Subject: MHI's Response to US-APWR DCD RAI No. 304-2330 Revision 1

MHI's Response to US-APWR DCD RAI No. 304-2330 Revision 1

RAI NO.: NO. 304-2330 REVISION 1
SRP SECTION: 15.02.06 – LOSS OF NON-EMERGENCY AC POWER TO THE STATION AUXILIARIES
APPLICATION SECTION: 15.2.6
DATE OF RAI ISSUE: 4/02/2009

Figure 15.2.6-1.1 DNBR versus Time
Loss of Non-Emergency AC Power to the Station Auxiliaries

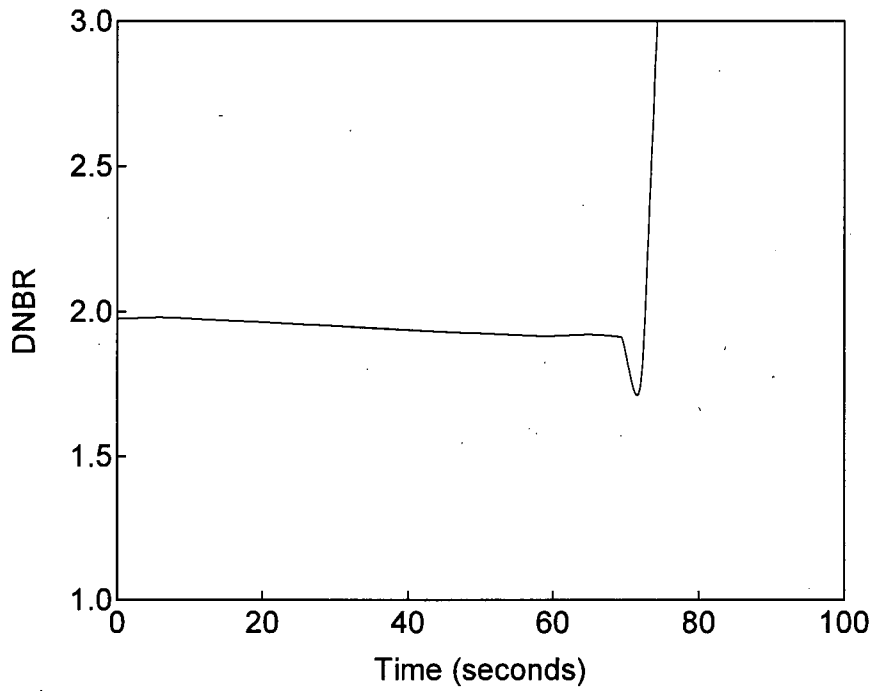
Provide the transient curve for DNBR verses time in the Section 15.2.6 analysis.

As described in DCD Subsection 15.2.6.3, the minimum DNBR for the loss of non-emergency AC power to the station auxiliaries in Subsection 15.2.6 is bounded by the minimum DNBR for the complete loss of flow event analyzed in Subsection 15.3.1.2. The reason why the complete loss of flow is more conservative for calculating the minimum DNBR is that the RCP coastdown begins 1.1 seconds before reactor trip, as shown in DCD Table 15.3.1.2-1, whereas for the loss of offsite power (LOOP) the reactor will trip at the same time as the RCP coastdown due to the low steam generator water level signal, as shown in DCD Table 15.2.6-1. The transient curve for DNBR versus time for the LOOP analysis in DCD Subsection 15.2.6 analysis is shown below in Figure 15.2.6-1.1.
